6.1.1 Amendment C268 - 49 Garfield Road, Garfield

Cardinia Planning Scheme Amendment C268card and Planning Permit Application T190104 49 Garfield Road, Garfield

Cardinia Planning Scheme Amendment C268card_u and Planning Permit Application T190104

Figure 7 Council's proposed changes to the habitat connections

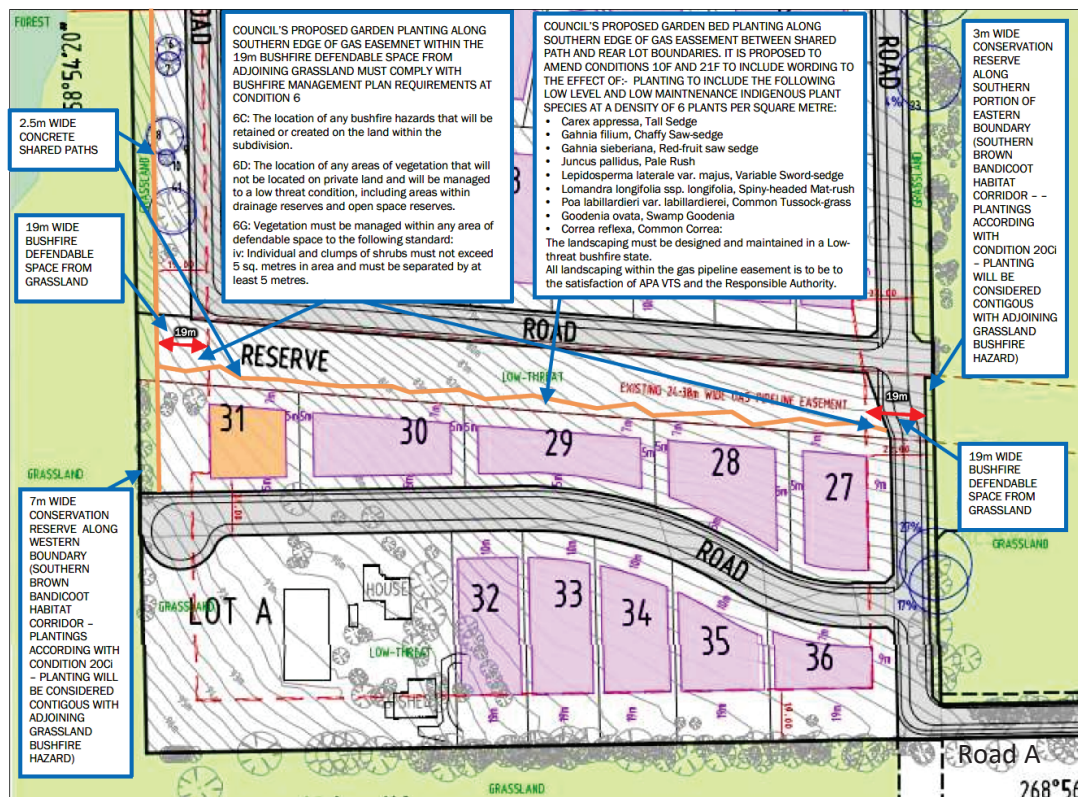
- that the proposed east–west gas pipeline reserve could be appropriately planted and form a connection between the two north–south habitat reserves, and
- -a wildlife underpass was included from the eastern reserve under the access road to the gas pipeline reserves.

1. Council should discuss the proposal with both the APA VTS Australia (Operations) Pty Ltd (APA) and the Country Fire Authority (CFA) to ascertain whether a wildlife corridor along the southern edge of the gas mains reserve would be supported.
2. Once Council has a response from APA and CFA it should confer with the proponent to about whether to proceed with the proposal.
3. Whether there is agreement or not all parties should respond to the Panel in writing by 12.00 noon on Friday May 5, 2023.
4. Council should provide its final version of the draft planning permit T190104 in MS Word format with all its proposed post exhibition changes marked by tracked change by 12.00 noon on Friday May 5, 2023.

Council proposes to amend the landscape requirements at conditions 10.f. and 21.f of the proposed planning permit to ensure the planting in the garden bed along the southern edge of the proposed Council Reserve / Gas Pipeline Easement can assist the endangered Southern Brown Bandicoot to move more safely in an east–west direction across the subject land.

Council also proposed to amend the bushfire defendable space requirements at condition 6.e.v. to increase the bushfire defendable space distance at each end of the Reserve/Easement from 19m to 20m. This will ensure the proposed planting cannot be classified as a bushfire hazard in its own right under *AS 3959-2018 Construction of Buildings in Bushfire-prone Areas*.

Council provided a revised planting proposal (Document 11) which included the required changes as shown in Figure 7.
